PARKWAY PLACE SUBDIVISION

APPLICATION NUMBER 16 DATE December 6, 2012
APPLICANT Parkway Place Subdivision
REQUEST Subdivision

DETAIL SITE PLAN

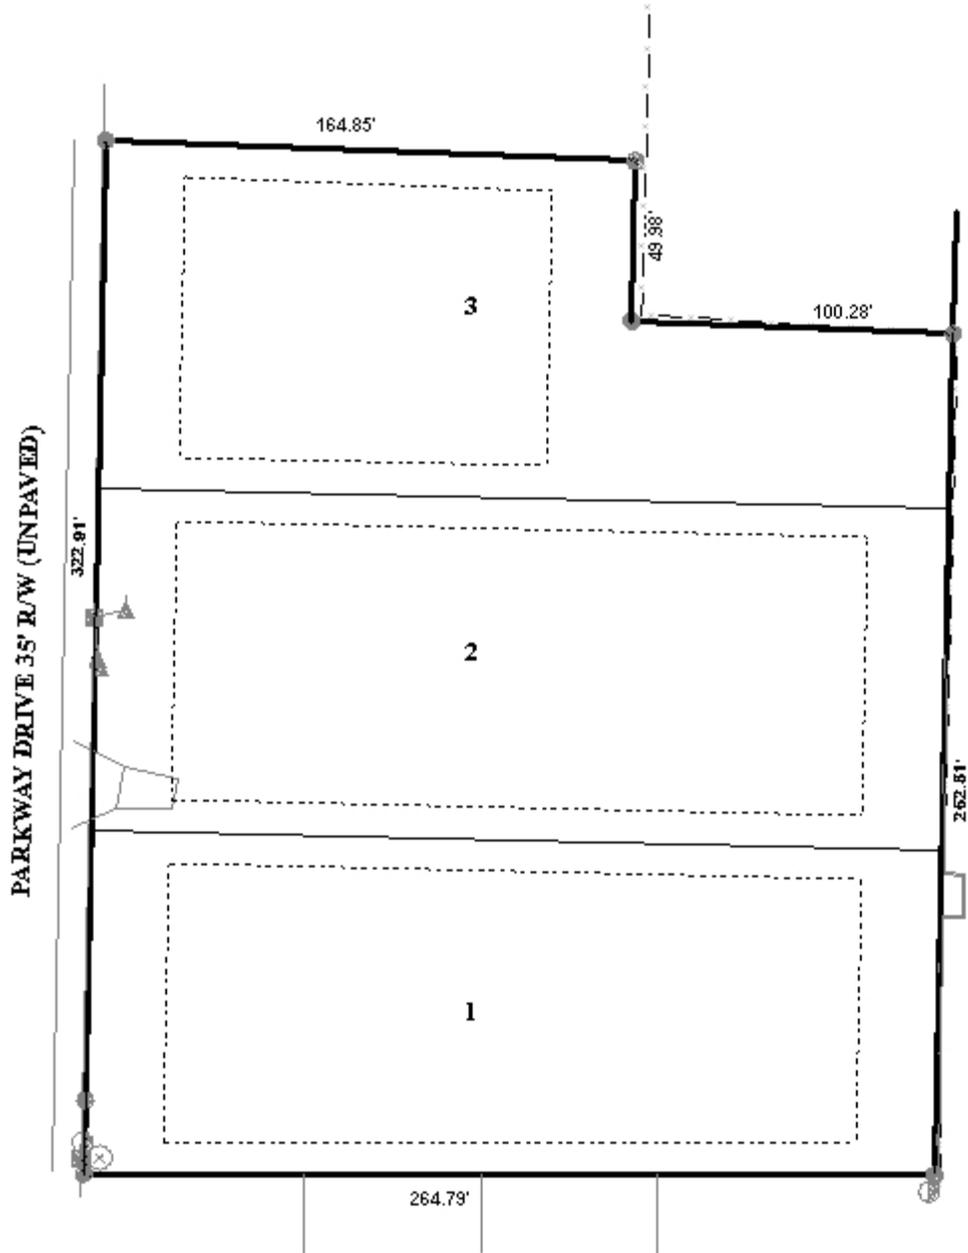
The site fronts onto Parkway Drive, a minor street with a 35-foot wide right-of-way. Parkway Drive is paved along most of the frontage of the subject site, but is unpaved and perhaps even unimproved for the last 80 feet of frontage, where it then terminates in a barricade which blocks entrance into a private road associated with the Cedar Bend development to the South. As a paved and unpaved street lacking curb and gutter, the right-of-way should be a minimum of 60 feet, thus dedication sufficient to provide 30-feet from centerline should be provided. Furthermore, as the site is at the terminus of Parkway Drive, which has no provisions for a turn

around of any sort and traffic is blockaded from continuing South onto the private streets associated with the Cedar Bend development. As such, it is recommended that the lot layout be revised to include the provision of a cul-de-sac, as specified by Sections V.B.14. and V.B.15. of the Subdivision Regulations, or some other turn-around that complies with the 2009 International Fire Code, as locally adopted.

Each lot will have a frontage of approximately 100 feet on Parkway Drive, thus each lot should be limited to one curb-cut each, with the size, design and location of all curb-cuts to be approved by Traffic Engineering and conform with AASHTO standards.

The 25-foot minimum building setback line, required in Section V.D.9., is not identified on the preliminary plat. Lines on the plat appear to depict a 25-foot front setback, 10-foot side yard setbacks, and a 25-foot minimum rear yard setback. The lines also enclose an area, implying a maximum building footprint. The Subdivision Regulations only regulate the front yard setback. The Zoning Ordinance would minimally require a 25-foot front setback and an 8-foot side and rear yard setback for an R-3 site, and would limit the maximum building footprint for the site to be 45%.

- 1) Dedication of right-of-way sufficient to provide 30-feet from the centerline of Parkway Drive;
- 2) Dedication of right-of-way sufficient to provide half of a turn-around complying with Sections V.B.14. and V.B.15. of the Subdivision Regulations, or at minimum meeting the requirements of the 2009 International Fire Code, as locally adopted;

- 3) Revision of the plat to label the 25-foot setback line, after any required dedication;
- 4) Revision of the plat to depict a common detention area, if one will be provided;

- 5) Revision of the plat to label each lot with its size in square feet, or placement of a table on the plat with the same information; and
- 6) Placement of a note on the plat stating that approval of all applicable Federal, state and local agencies is required for endangered, threatened or otherwise protected species, if any, prior to the issuance of any permits or land disturbance activities.
